Tailings Thickening Plant modifications

Tbilisi 2023

1. BACKGROUND AND REFERENCES INFORMATION

2.1 Underflow pumps

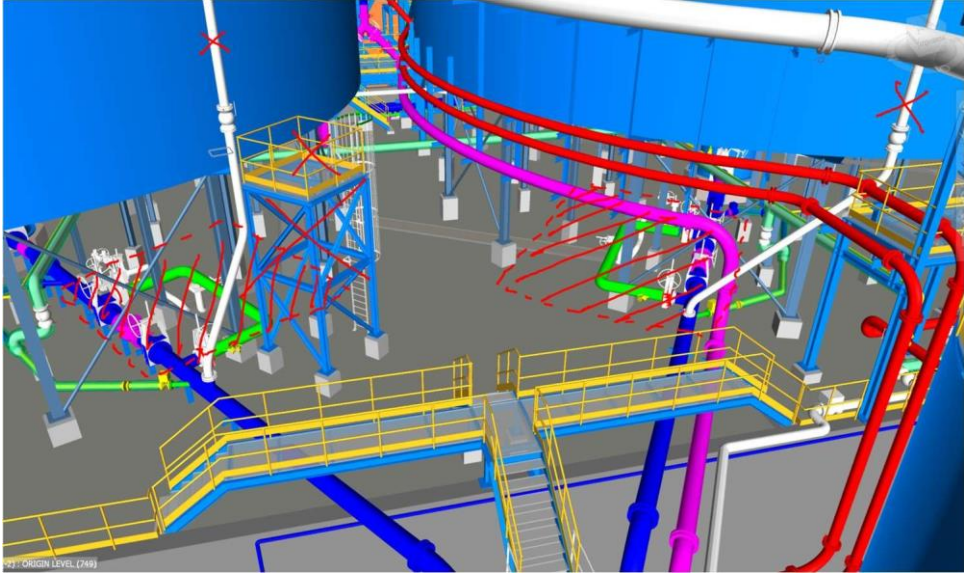
Thickeners underflow changed from gravity flow controlled by regulation valve to pumped, for both thickeners.

Equipment and piping layout to be reconfigured in the area under the thickeners, with some updates required for civil work and electrical (new cable trays to the pumps).

The configuration with two pumps in bypass need to be checked by process. This proposal is considering a probable second outlet from the thickener for the second pump.

Pipe vents and it's access are probably not required as they are related to the underflow by gravity.

2.2 Tailings pumps train reduction

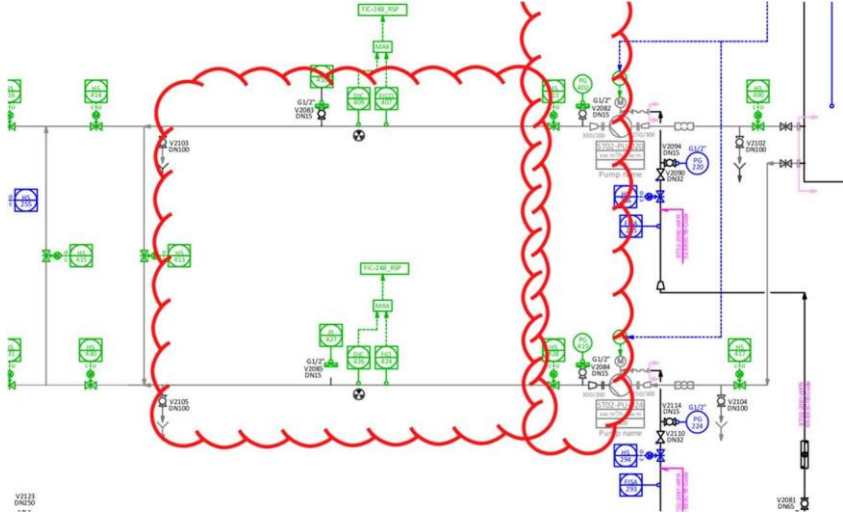
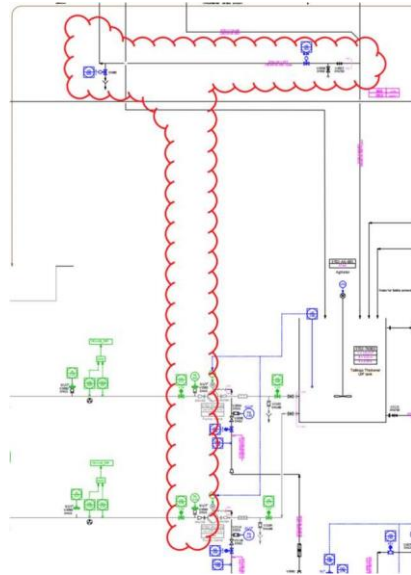
This change affects to the tailings pumps building. As tailings are no longer delivered to a tailings storage facility (TSF) but to a much closer Filtering Plant (about 300 m), there is no need to install 4 pumps in series for each tailing pumping line. The number of pumps is reduced to one, for each line, according with next diagram. PU-021 to 023 and 025 to 027 are removed.

The bed mass formation is done now by the new UF pumps. Same as shown below applies to both thickeners.

Piping must be modified according with new PID.

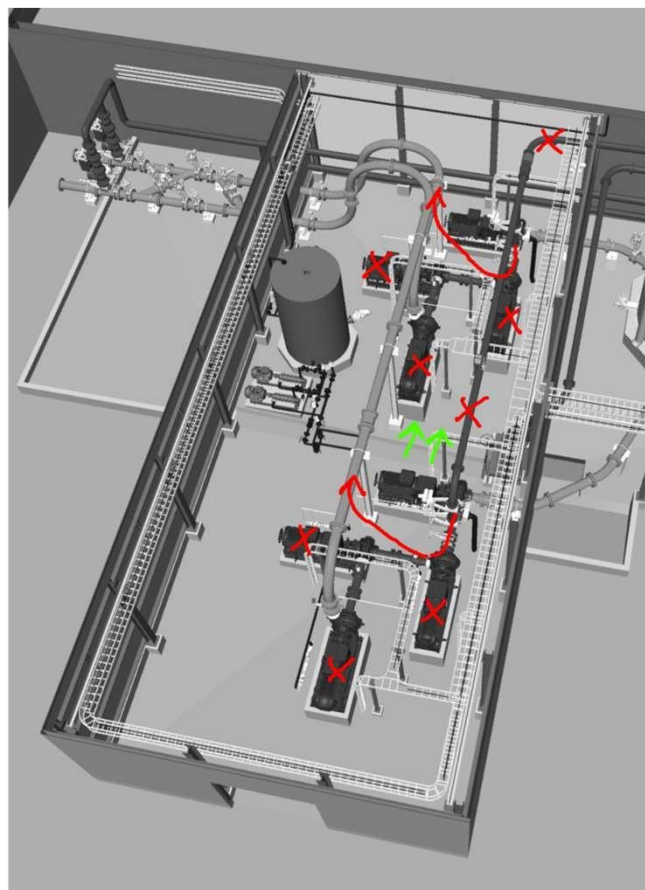
Pipes from underflow tank may require modification due to pump relocation.

Gland seal water system to be modified as well. Gland seal water tank capacity may be reduced too.

2.3 Tanks area height increase

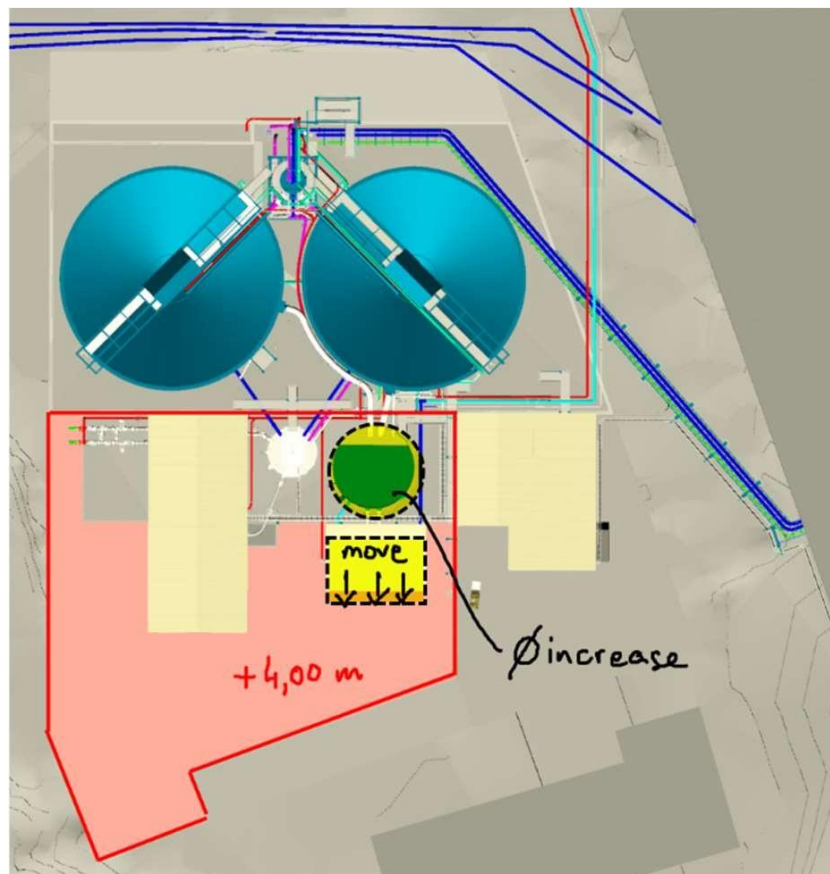
Rising approximately 4 meters of tank support level to equal MCC level.

Overflow tank diameter was increased to keep the position and allow overflow by gravity as it was. The new dimensions of the tank may affect to the water pump building position.

Tank access platform update is required too.

Civil works, piping, steel structure (stairs structure and buildings, only 3D model) and cable trays to be modified accordingly.

2.4 Tailings screening before feed tank

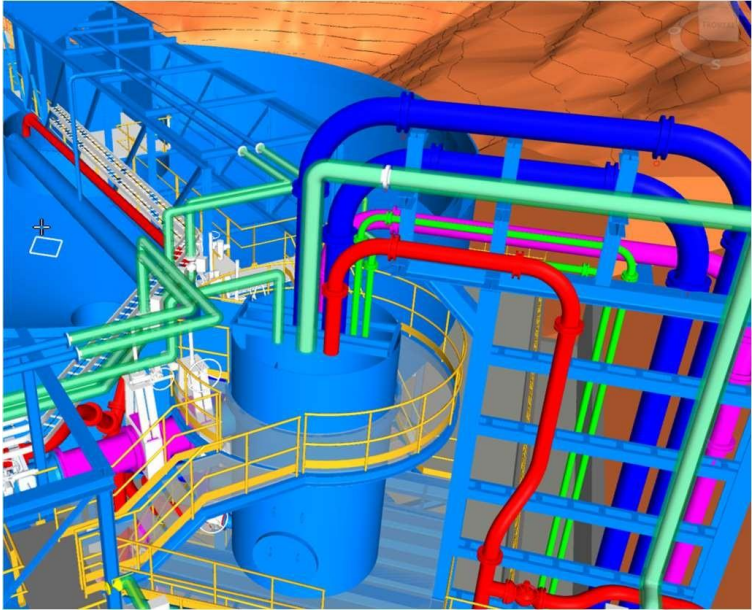
Screening equipment is required before the feed tank to avoid coarse material to enter into the tailings thickening plant and later on to the filtering plant, affecting to the filter press equipment. This screening equipment must be defined (dimension and position) at least roughly, in order to evaluate the workload required for the changes to be implemented on top of the feed tank platform.

Equipment layout, piping and steel structure to be affect in this area.

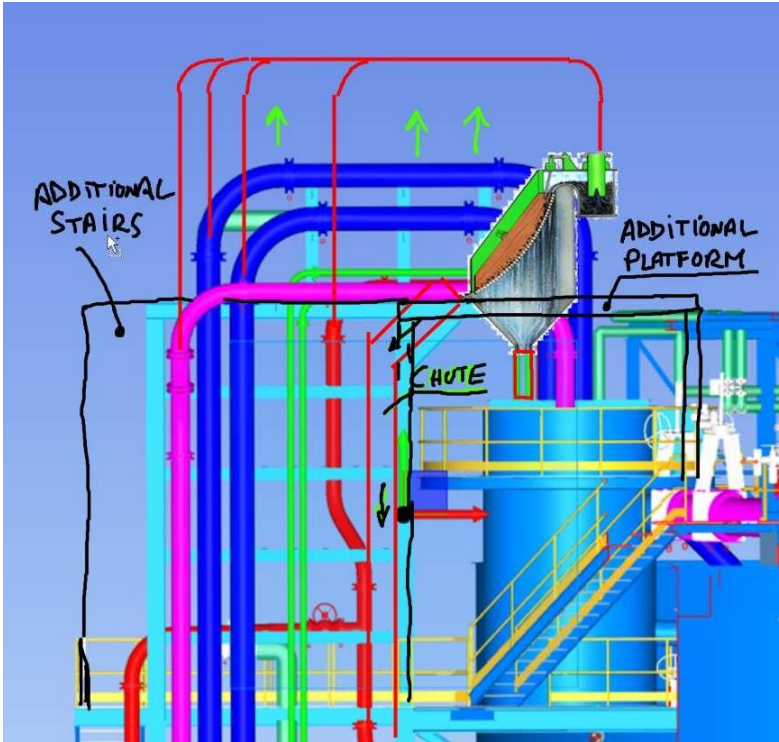
As at the time of development of this Technical Requirements Specification, the size and specification of the screening equipment is not known, for the purpose of the workload estimation for this proposal, a sieve bend equipment is considered installed on top of the feed tank, modifying the supporting and access structure accordingly. The diversion of coarse material will be done by a steel chute to a steel bin in the thickener support level(ground), from where it will be periodically retired by forklift. An approximate solution is shown in the next sketch:
